Planning Commission, Austin, Texas

Reg. Mtg. 4/25/78

Regular Meeting --- April 25, 1978

PRELIMINARY SUBDIVISIONS

RICHARD C. BAKER
Vol. 3642 PG. 8
PRELIMINARY PLAN OF
SPICEWOOD HILLS

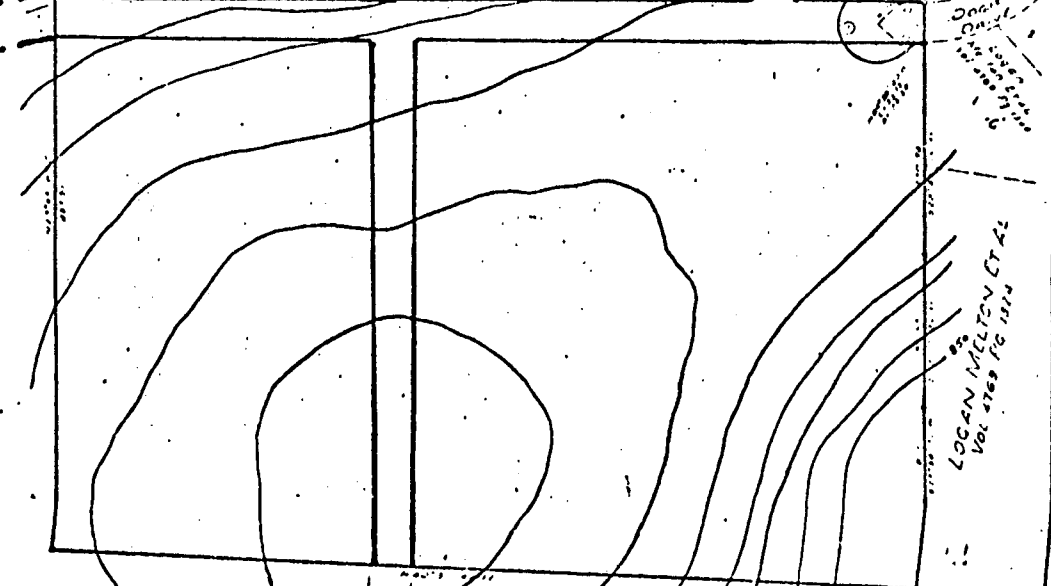
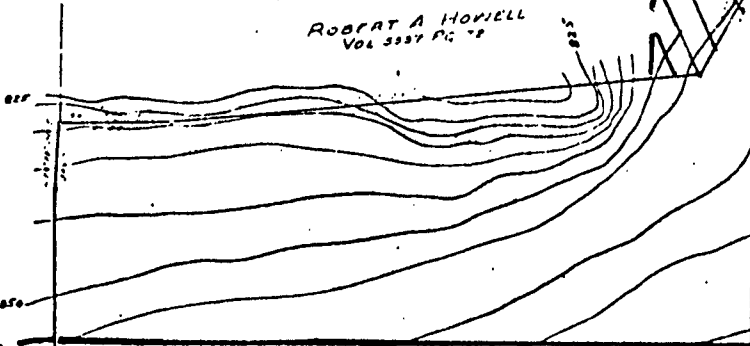
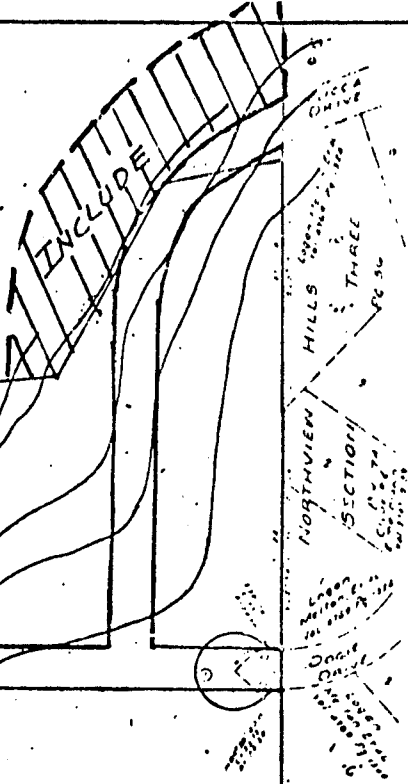
The staff recommends DISAPPROVAL of this preliminary plan and final plat, and further recommend that a REVISED preliminary plan be submitted with provision for the extension of Dogie Dr. to the west boundary of this tract, provision for extension of Yucca Drive to connect (at right angles) to Dogie Dr. and provision for a street connection between Dogie Dr. and the south boundary of this tract.

Such REVISION is required to provide access and circulation to adjacent properties which are dependent on such access because of topography, and to eliminate necessity of variances on the length of existing dead end streets, which were layed out and approved for extension through this tract, and which the staff cannot support.

A sketch is attached hereto showing an acceptable revision as recommended above, however, other modifications could be considered with provision for street access to the west and south.
